WATER DISTRIBUTION SYSTEM IMPROVEMENTS

ONERISE ADDITION

PROJECT NO. 448-2023-031781

TITLE SHEET

SHEET NO.
CU001-W01
01 OF 11

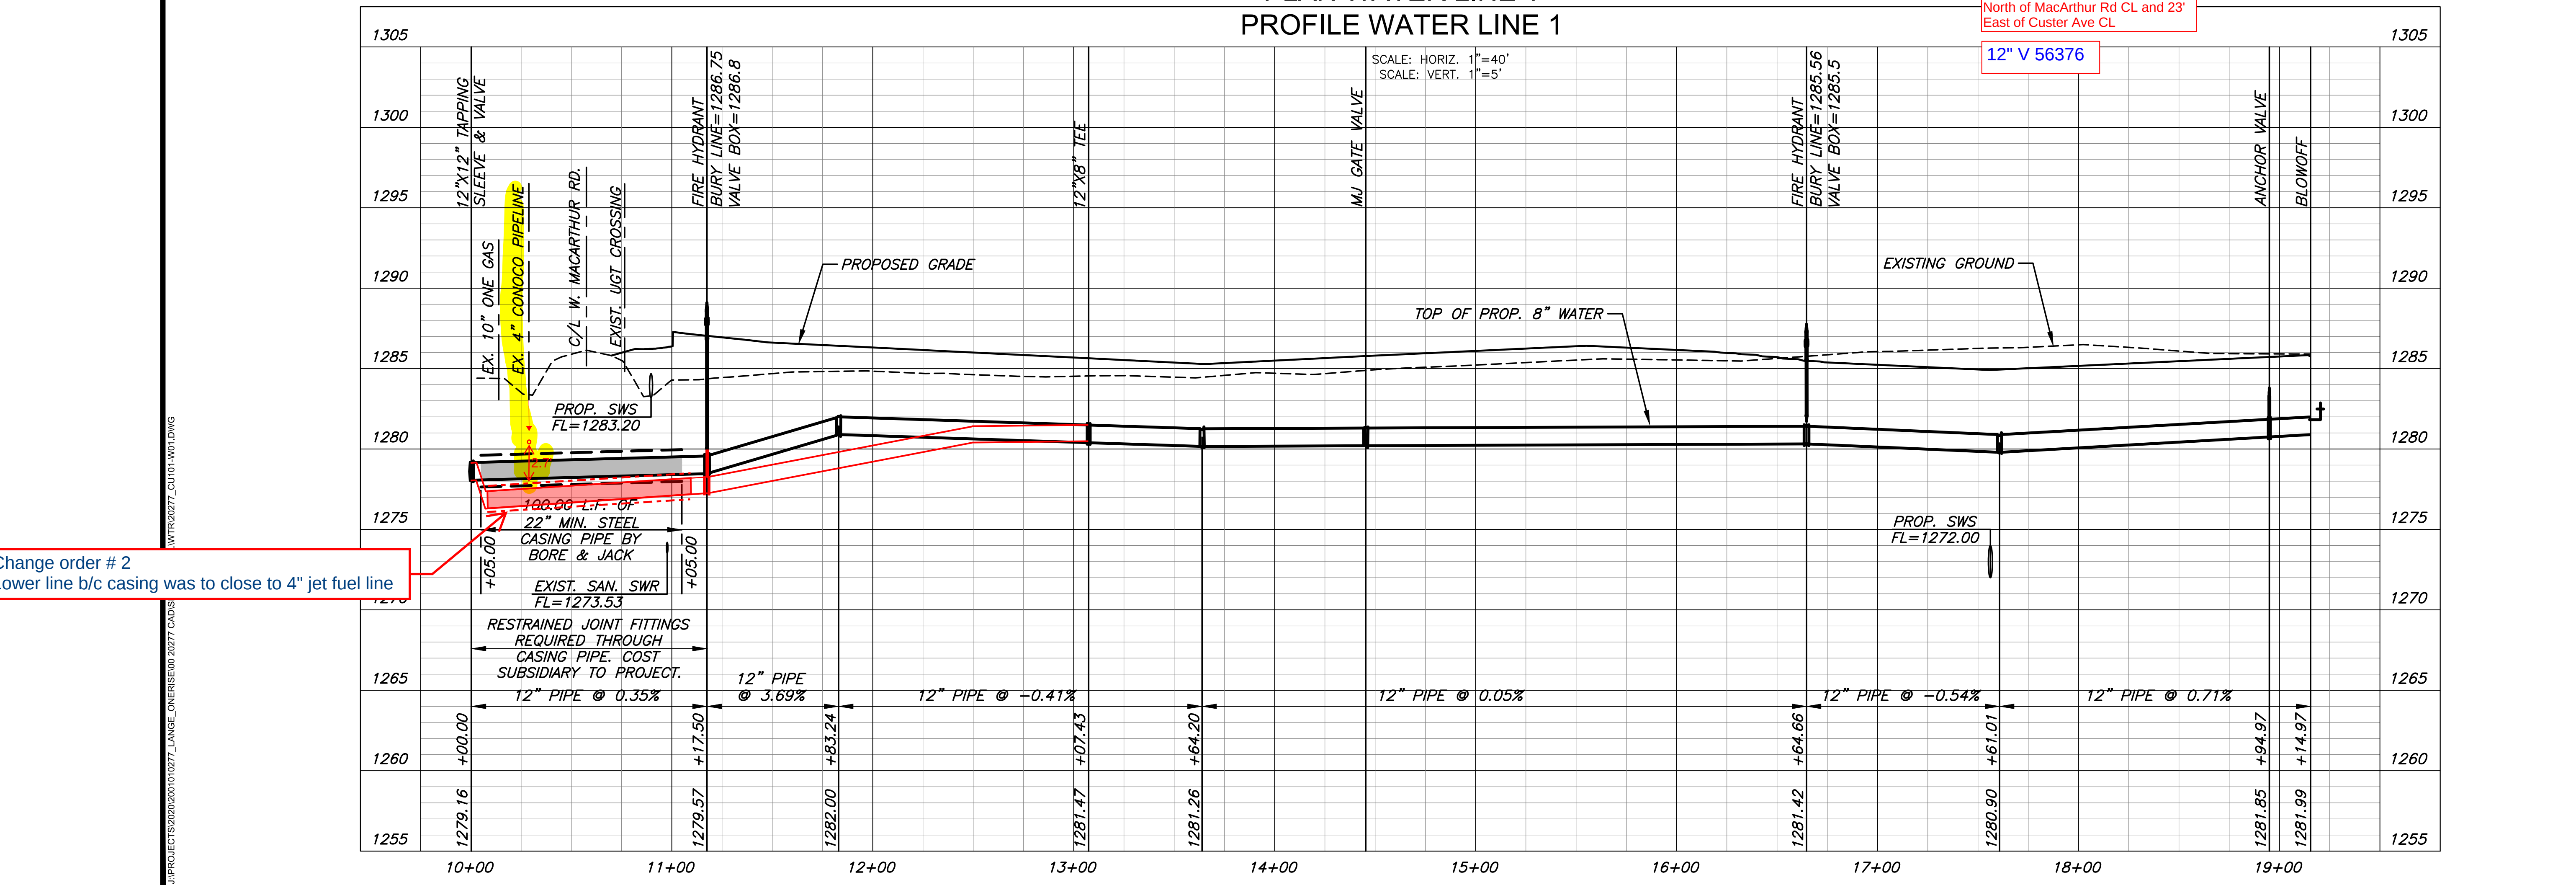
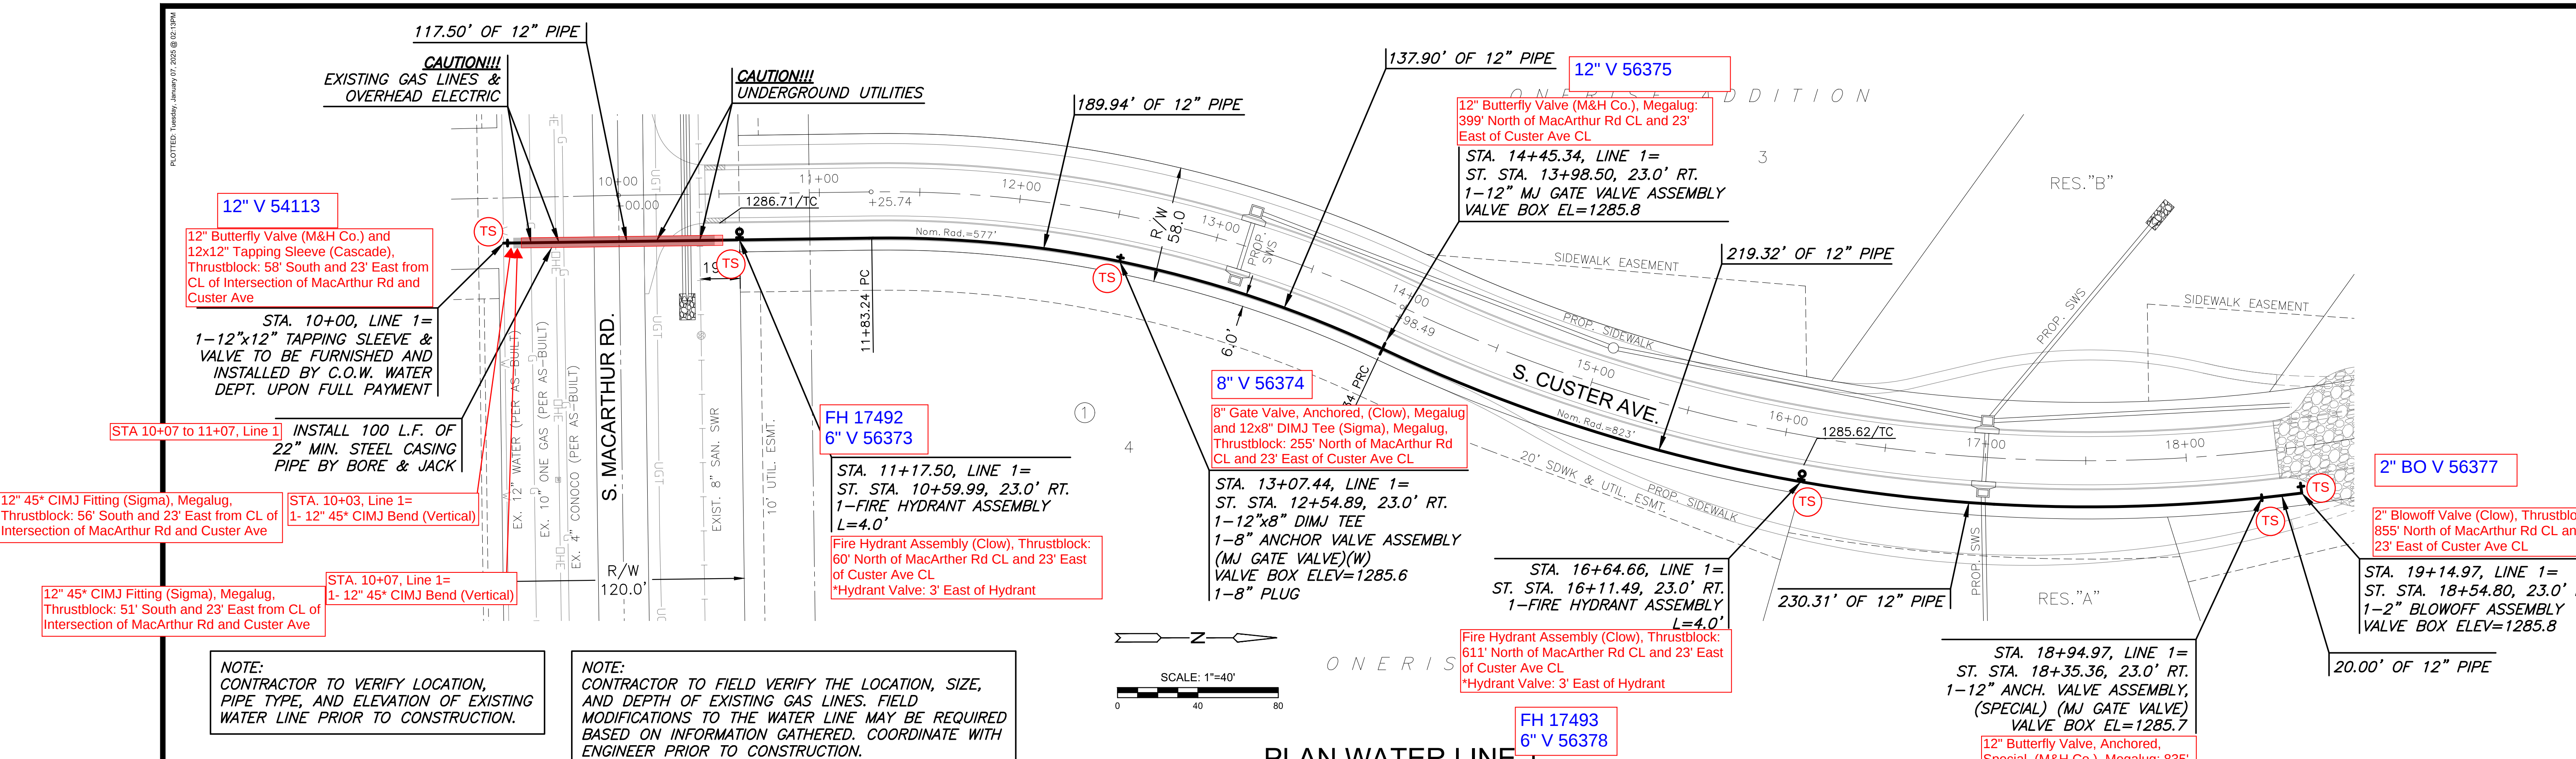
Change order # 2
Lower line b/c casing was to close to 4" jet fuel line
